Official Transcript of Proceedings
NUCLEAR REGULATORY COMMISSION

Title: Advisory Committee on Reactor Safeguards
Power Upgrades Subcommittee - Open Session

Date: June 22, 2012

9 MR. JENSEN: Okay. Now that we've
10 overcome that technical difficulty, I'll get started.
11 Good morning. My name is Joe Jensen. I am the Site
12 Vice President for the St. Lucie nuclear power plant.
13 I want to thank the Subcommittee for the opportunity
14 to speak on behalf of Florida Power and Light
15 regarding the extended power uprate of St. Lucie Unit
16 2.

LEFM ✓ + System Overview

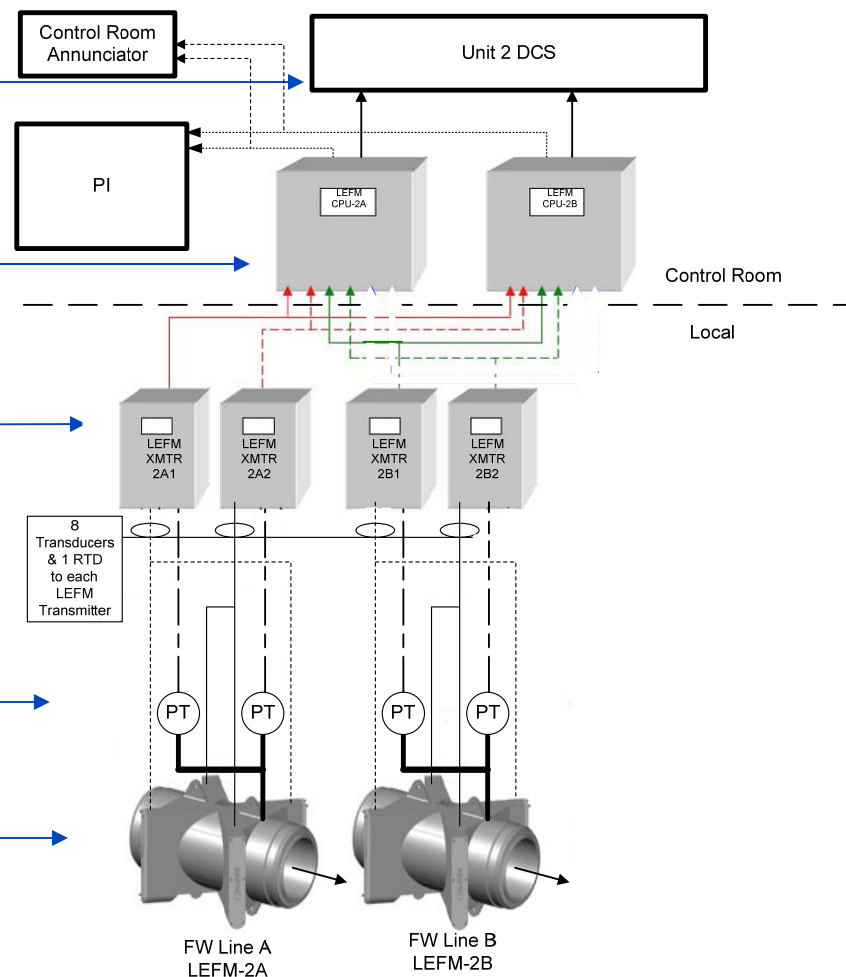
19 MEMBER BROWN: So in the absence of
20 diagrams and some architectural representation of
21 where this information goes to, it gives the clear
22 impression it just disappears out of the plant and
23 gets siphoned off via some Ethernet connection to
24 outside world, the Internet, corporate world,
25 whatever.

1 There was no mention, relative to the
2 cybersecurity, what type of reg guides or what
3 interfaces govern, for instance, RG 5.71, which lays
4 out a level of isolation for critical plant data,
5 which this is. It also leaves open the question about
6 whether somebody could get in and modify that data as
7 it is being presented to the operators, if you've got
8 an Ethernet connection coming into the DCS.

9 So I don't know how you're going to
10 explain all that in this particular meeting, but I did
11 want to make you aware that somewhere along the line,
12 I would like to get a clear understanding of why
13 nobody is ever going to be able to get in. RG 5.71
14 makes it fairly clear that if you're going to
15 communicate outside the main plant, it should be a one
16 way only communication link.

9 MEMBER BROWN: Or whether it has access,
10 people can actually access it and tell the PI system
11 to do things or provide information to them. Because
12 if you're connecting with that via the Ethernet system
13 as well, then you're just daisy-chaining the dual bi-
14 directional communications all the way into the plant.

21 MEMBER BROWN: So the thousand words will
22 replace a simple diagram, right?

10 Several methods to do that. Some can be
11 done externally via remote mains; some have to be
12 executed at the device itself by manual means. So my
13 question is what kind of one-way diode? Even if it's
14 deterministic, it can still be executed either way.

4 MR. HOFFMAN: Yeah. Let me just add on to
5 what Steve has said. Several years back, going from
6 analog to digital technology, we implemented a
7 distributed control system is what we call it or DCS
8 in the control room, that provides the operator --
9 there's a number of different systems that communicate
10 with the Distributed Control System in the control
11 room, to provide operators with much better
12 information, touch screens and what-not, and that is
13 isolated from the outside world.

14 That is a system that is specific and does
15 not communicate outside the control room. The way we
16 implemented the Leading Edge Flow Meter modification
17 is we simply, using the DCS as the what I'll call the
18 brains to do the calorimetric calculation, the outputs
19 of the LEFM provides the inputs into the DCS to do the
20 calorimetric calculation.

21 The calorimetric information is displayed
22 in the control room. The calculated calorimetric
23 information is displayed in the control room, and
24 that's not communicated with the outside. That
25 information, correct me if I'm wrong Todd, is used by
